**THE GILINSKY/BRADFORD
DISSENTING OPINION ON
NRC'S FAILURE TO REVIEW
THE APPEAL BOARD'S
APPROVAL OF DIABLO
CANYON'S SEISMIC DESIGN**

(Diablo Canyon Nuclear Power)
Plant, Units 1 and 2))
)
)

Docket Nos. 50-275 OL
50-323 OL

OPINION OF COMMISSIONERS GILINSKY AND BRADFORD ON COMMISSION
REVIEW OF ALAB-644 (DIABLO CANYON SEISMIC PROCEEDING)

DIABLO CANYON CONTAINMENT STRUCTURE
 COMPARISON OF VARIOUS ELASTIC RESPONSE SPECTRA

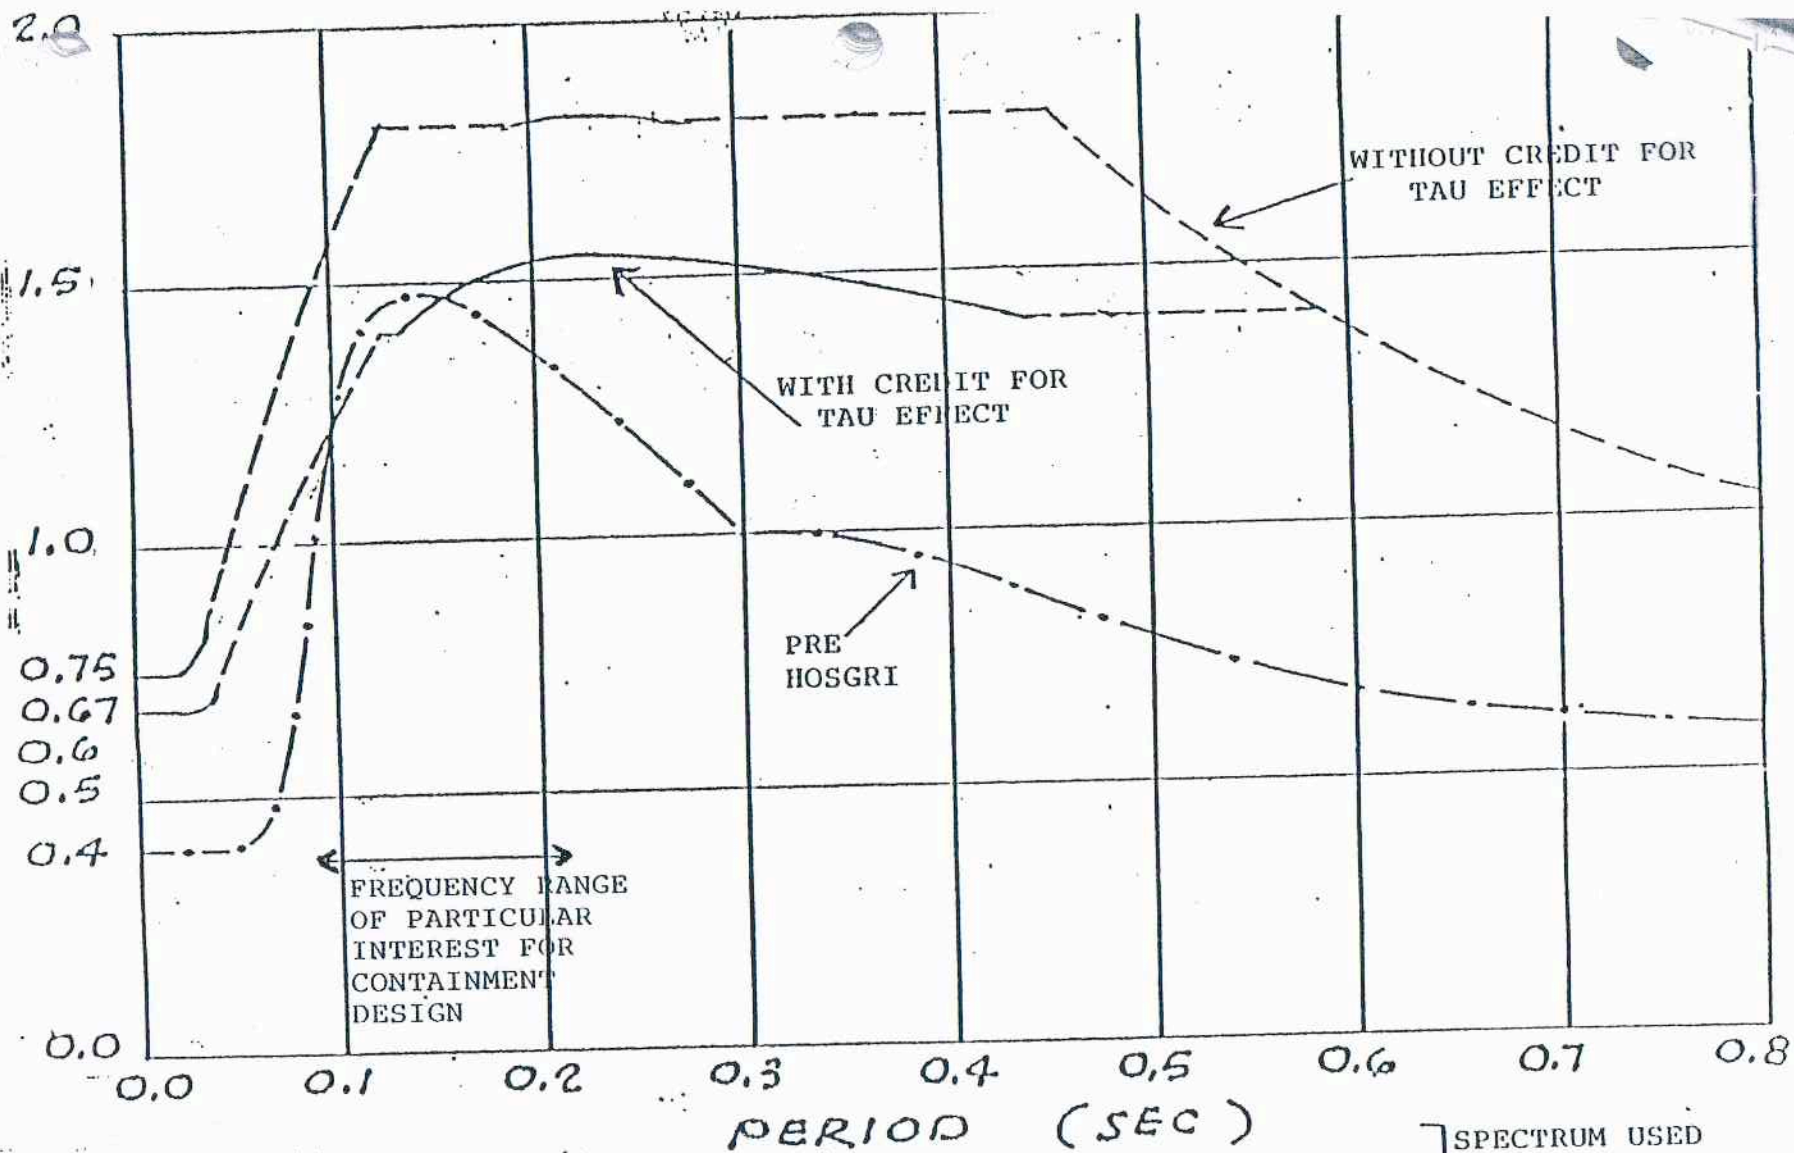
With the changes and adjustments permitted by the Board it turns out that the post-Hosgri seismic response spectrum does not in all respects represent a more severe seismic standard than the one used before the discovery of the Hosgri fault. As the accompanying diagram illustrates, in the frequency range between 5 and 10 hertz (cycles per second), a range of particular interest in the analysis of the containment building surrounding the reactor, the two response spectra are quite close.¹⁰ For part of this range, in fact, the old spectrum shows a higher response. In other words, for that part of the range the original design conditions were more demanding than the new ones imposed after the discovery of the Hosgri fault. This new

spectrum is the basis of the engineering reanalysis and ultimately determined the extent to which the containment was to be modified. Not surprisingly, in view of the above, only minor changes were required in this area.
